## AG-MI-2013-10-C-EN – Retrofit Throttle Turbo Detent

Cavalon equipped with Rotax 914 engine, serial numbers up to and including V00131

Installation of component 'Upgrade Throttle Turbo Detent'

Fig. 1 – Demounted centre panel

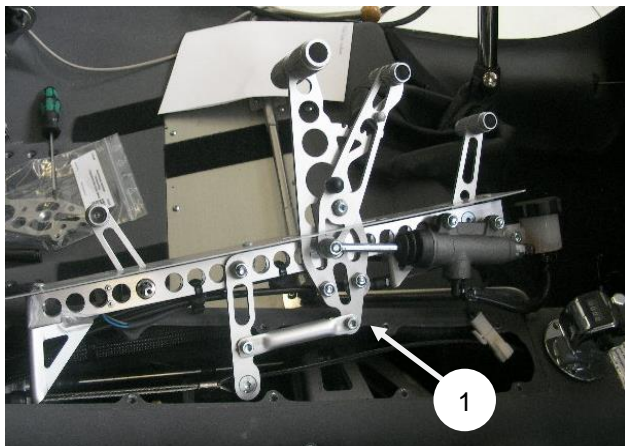
- 1 Verification whether Throttle Turbo Detend is installed (functional test)
- 2 If not installed demount centre panel according to MMM 67-10-00 4-1 (Fig. 1)

Fig.2 – Lower throttle connection

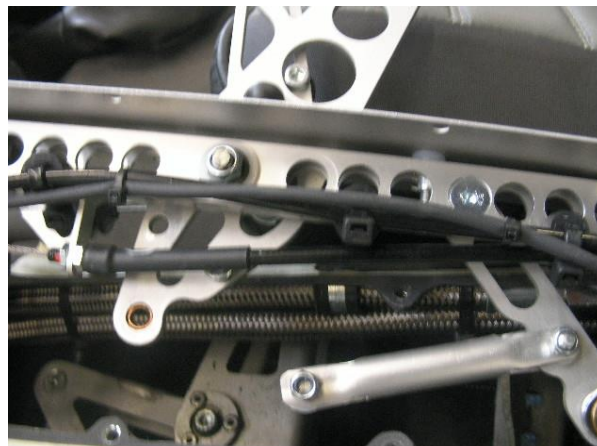
- 3 Lower throttle lever connection – demount front bolt of gas push rod (Fig. 1, 1 and Fig. 2)
- 4 Demount excentric for idle adjustment
- 5 Demount brake lever (Fig. 3)

Fig. 3 – Dismounting brake lever

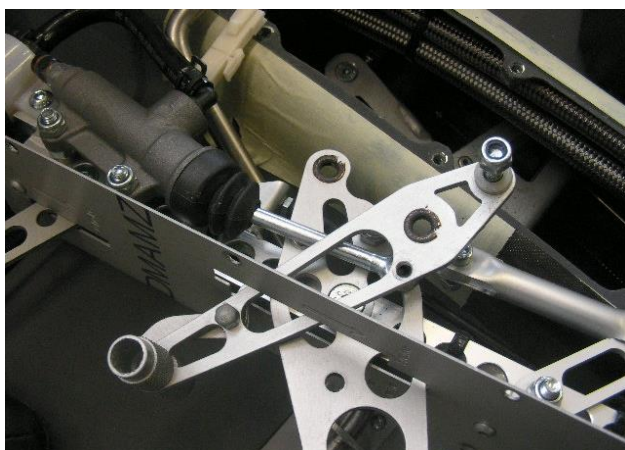
- 6 Brake lever: Demount stop screw
- 7 Shove in brake lever until screw of brake actuator push rod is accessible. Demount push rod (Fig. 3)
- 8 Demount front throttle lever stop screw (Fig. 4)

Fig. 5 – Turbo detent

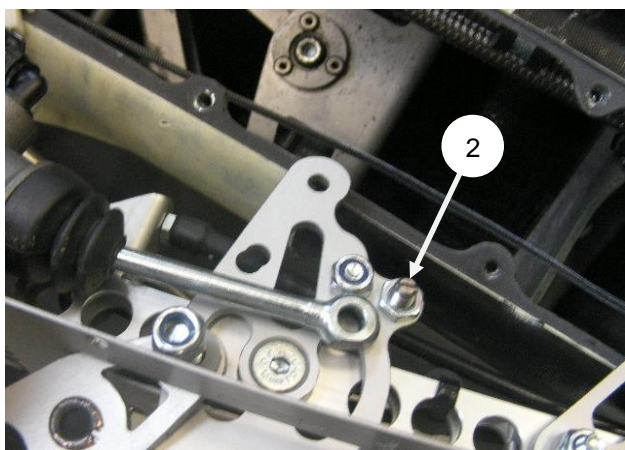
- 9 Demount throttle lever
- 10 Insert and fix new throttle lever
- 11 Mount turbo detent (Fig. 5, 2)
- 12 Mark contact point of turbo detent on centre panel. Degrease marked contact point with power cleaner and affix protective plate with Technicoll (Fig. 6, 3)
